Rev B - two rear rooflights retained; raised-ground access and landing clarified.

Rev No:	Revision:	REV:	SCALE:
		B	1:50 @ A2
			DATE:
			21.10.25
SWIFT OAK - Oak Frame Specialists -			
LOCATION:	CLIENT:	REV:	SCALE:
	C Ogilvy	B	1:50 @ A2
DRAWING No:	DRAWING NAME:		
CO/001	Three Bay 9 x 6m Full Height Frame; Plan & Spec		
DRAWING TYPE:			
Planning

Rev No:	Revision:	Date:
SWIFT OAK - Oak Frame Specialists -		
LOCATION:	CLIENT: C Ogilvy	REV: 1:50 @ A2
DRAWING TYPE: Planning	DRAWING No.: CO/002	DATE: 21.10.25
DRAWING NAME: Three Bay 9 x 6m Full Height Frame; Elevations

ACCESS DETAIL - SCHEMATIC, NOT TO SCALE

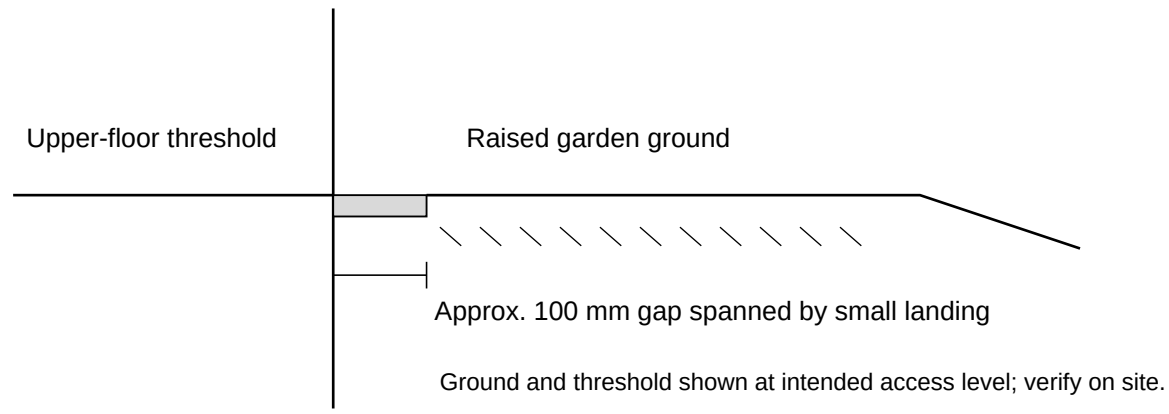
ACCESS CLARIFICATION - 05 OCT 2026

Raised ground and landing shown schematically from applicant information. Ground/threshold levels and landing construction require site verification.

Rear Elevation

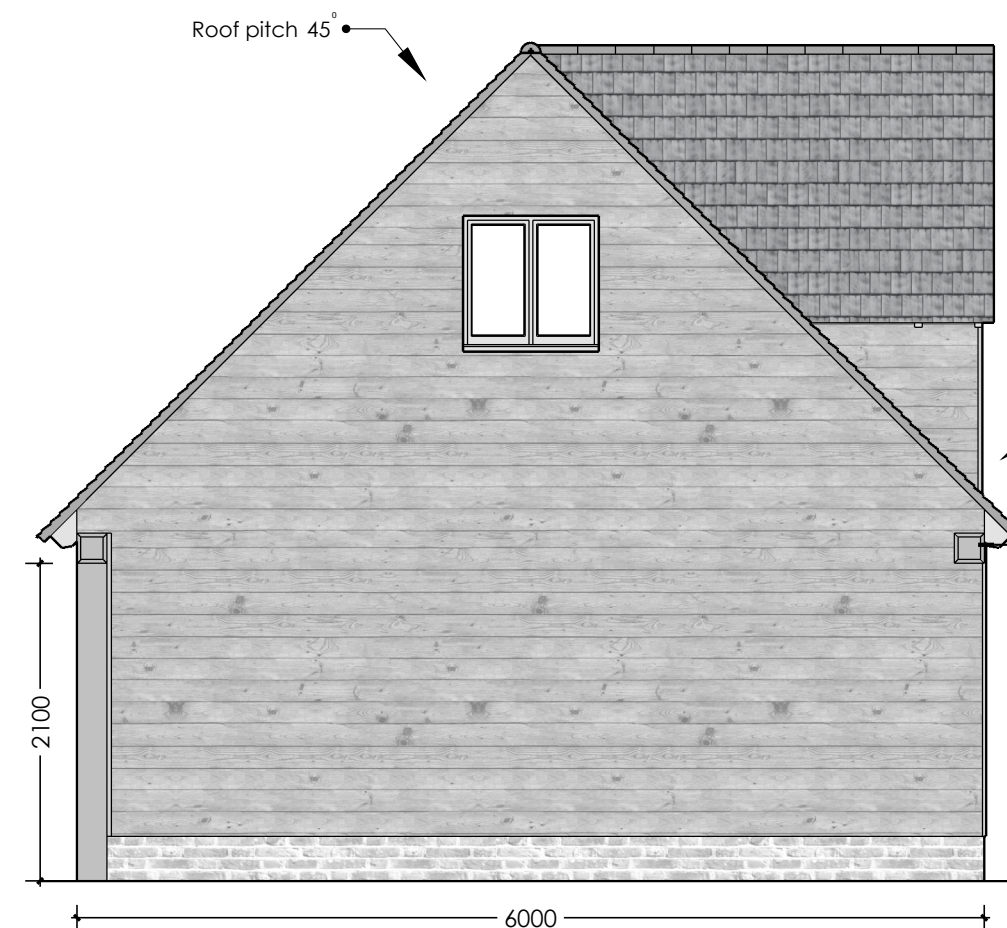
Adjoining raised garden
Approx. 100 mm gap at rear doorway
Small landing at access level
Indicative ground level; verify on site

Upper-floor access from adjoining
raised garden.
Small landing spans approx. 100 mm
gap.
No external staircase or ladder
proposed.

Raised garden at rear access
Small landing across approx.
100 mm gap; level indicative

ACCESS CLARIFICATION - 05 OCT 2026

Raised ground and landing shown schematically from applicant information.
Ground/threshold levels and landing construction require site verification.
